Ref: Emerson Place Subdivision  
Notice of Intent

I am writing to provide a revised subdivision plan, which addresses comments received during the permitting process and the Town's peer review consultant. In addition to a revised subdivision plan and stormwater report, the following items are attached to this letter;

The enclosed subdivision plans reflect a variety of revisions as a result of comments received by BETA and other Boards and Commissions. Most are minor but we did eliminate stormwater basins 3 and 4 in favor of a larger stormwater basin 2. The basins were renumbered accordingly. Additional information regarding the two proposed wetland crossings are included in the revised subdivision plan along with specifications for three box culverts at the intermittent stream crossings. These open-bottom box culverts are provided to restore the stream channels at each of the three crossings (which are now culverted with pipes or much smaller culverts). In order to meet the Applicant's regulatory requirement to control rates and volumes of flow to downstream properties, low-profile weir walls are proposed in each culvert bed to mimic existing flow conditions. The weirs allow for

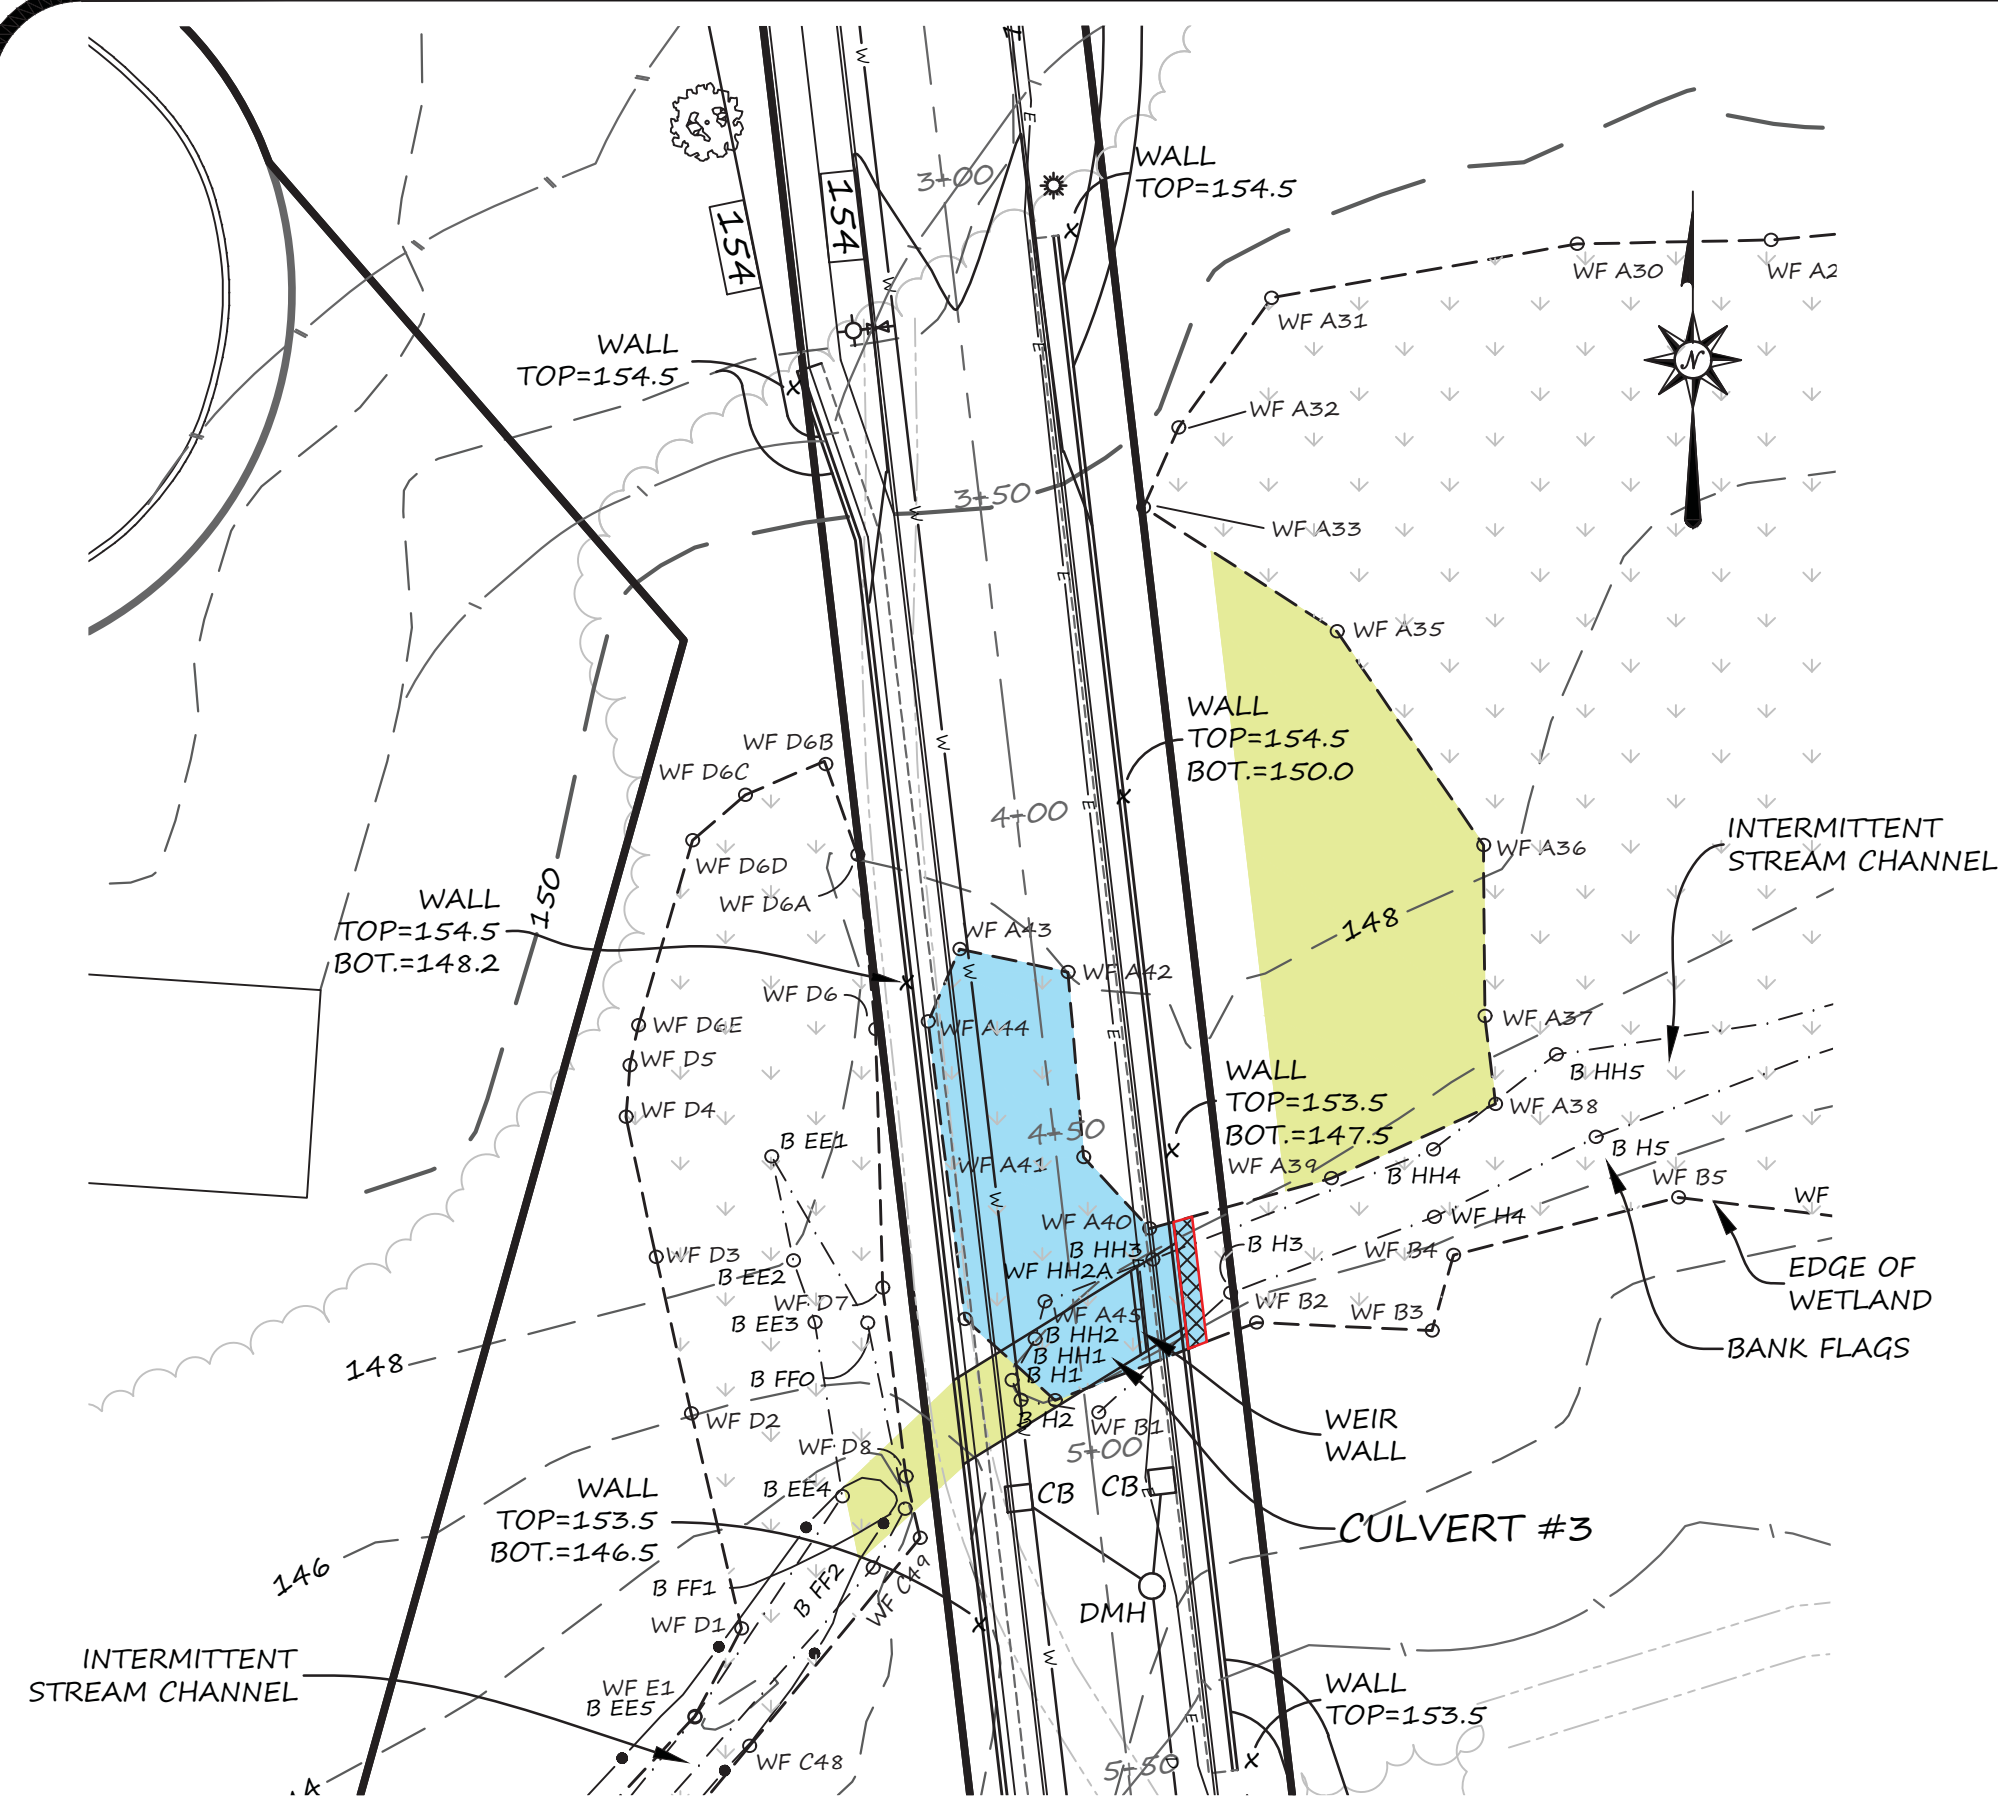
- BETA Comment:

- Response to 10-12: See Legacy Engineering's response.
